QUIKTRIP 4274

SITE PLAN, CONDITIONAL USE, AND PRELIMINARY PLAT

1st Review
Aurora Water
Jenny Wynn
jwynn@auroragov.org

1

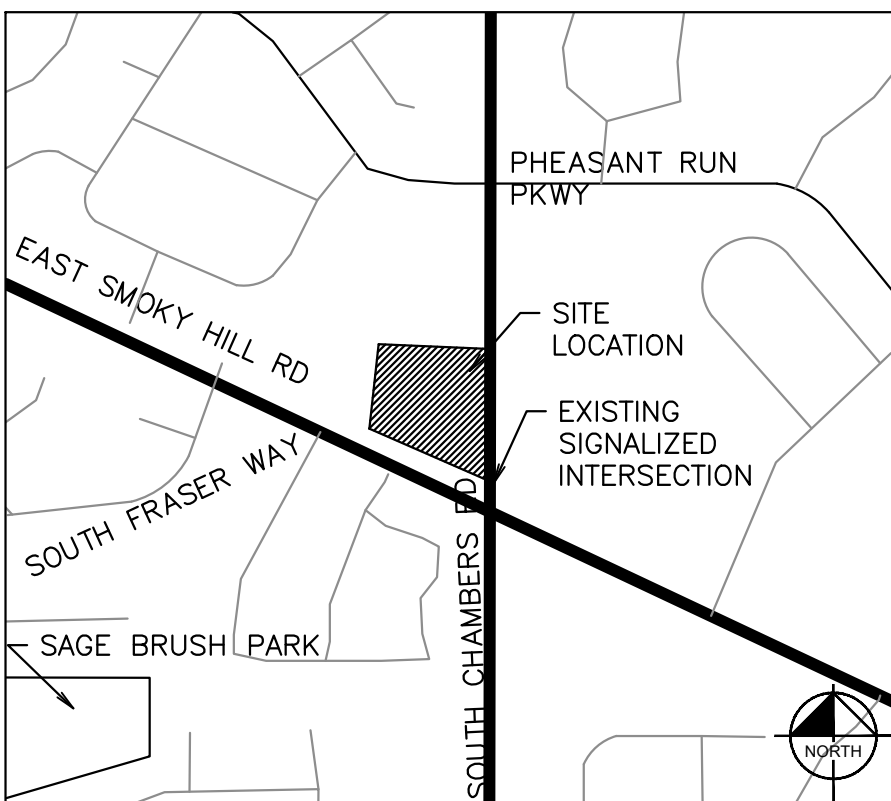
Do not include the plat in the site plan title.

Advisory Comment: Site Plan can not be approved until PDR is approved.

Sheets 9 thru 11 were omitted on this submittal. Provide lighting plans with the next submittal.

The photometric plan needs to be included in this set showing the site lighting spillover 10 ft into adjacent properties.

Removed from title.

Photometric included in 2nd submittal.

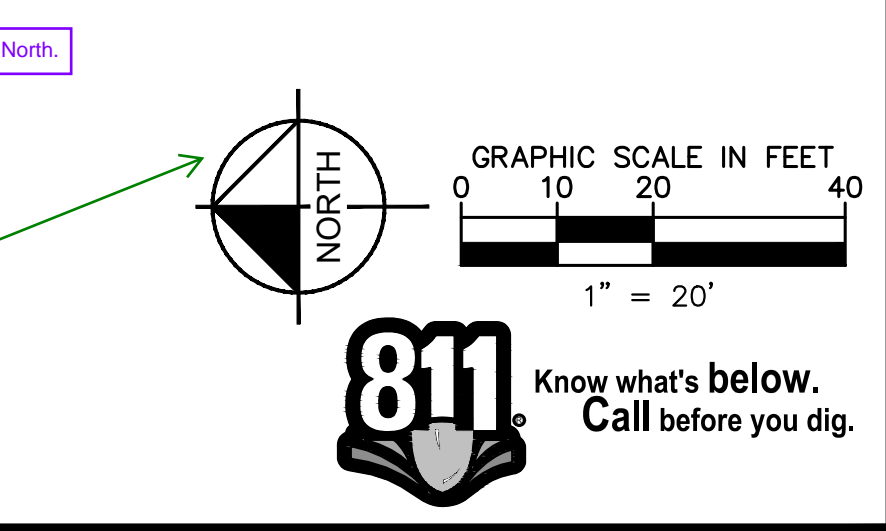
1.5" meter and tap already exist for this site. Please indicate that the old service will be abandoned and capped at the main if it is not being used

Callout existing street lights. Advisory note: Photometric analysis for ROW lighting of Chambers and Smokey Hill will be required with the civil plan submittal.

please specify as wet tap with size if necessary

Note added stating pavement material type cannot be determined until the time of construction.

OLD SERVICE TO BE ABANDONED AND CAPPED AT MAIN.

Existing street lights called out.

Specified as wet tap with size noted in callout on plans.

GRADING & UTILITY PLAN

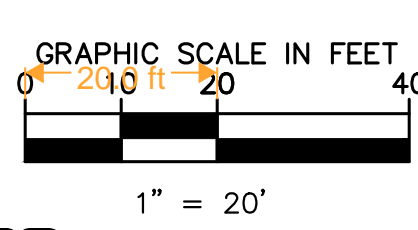
Private street, private driveway, parking lot drive, and fire lane grades, other than single family residential, may be up to 6% maximum when sloping up toward the public street. (4.05.4 of the 2023 COA Roadway Manual)

Min grade in asphalt is 1%, min grade in concrete is 0.5% (typ) (2.08.1.06 of the 2023 COA Roadway Manual)

max grade outside ROW is 3:1

Ramp crossing Chambers should be aligned with the direction of pedestrian travel. If paired ramps do not work well due to the skew of the intersection, we may consider a full drop ramp.

Please label sizes and materials of existing sanitary, storm, and water mains.

Show the proposed signal by HSIP and ensure you have the minimum 5'x5' landing. Per the pre-application notes, ensure your design is coordinated with COA signal design.

We recommend using the existing sanitary service for this site if possible.

If existing sanitary service will not be used, please specify that it will be capped at the main.

Add Note: The maximum cross slope in an accessible path shall not exceed two percent. The maximum longitudinal slope in an accessible path shall not exceed five percent.

Add Note: Minimum slope on unpaved areas is 2%, minimum slope on asphalt is 1%, and minimum slope on concrete is 0.5%.

Please show proposed easements on this page.

This driveway is an existing driveway and the current grades are being maintained. The driveway into the adjacent property site is low and cannot be altered because it is not within the property line. The driveway to the adjacent property to the west has been called out on the site and grading plan. The bottom of this driveway holds the bottom elevation of the driveway entrance into our site. The slopes on the driveway entrances off of Chambers match the existing grades.

This area will be graded as a minimum 1% per the grading plan.

This area will be less than 3:1 per our grading plan.

All sizes and materials of sanitary, storm, and water mains are now labeled.

Proposed signal design incorporated into plans. A minimum of a 5'x5' landing is incorporated into design.

The existing sanitary service is to the south of the building. The sanitary will exit the proposed building on the back on the north side. Due to the underground stormwater and fuel tanks in the parking lot area, the connection to the sanitary main at the existing location is not feasible, unless the service lateral ran in parallel to the existing main.

It is assumed the existing sanitary ties into manhole #1009. We are not utilizing this existing service and the pipes will be removed up to the property line and capped at the property line. We have no data on where this line ties into and what other service laterals are connected to it.
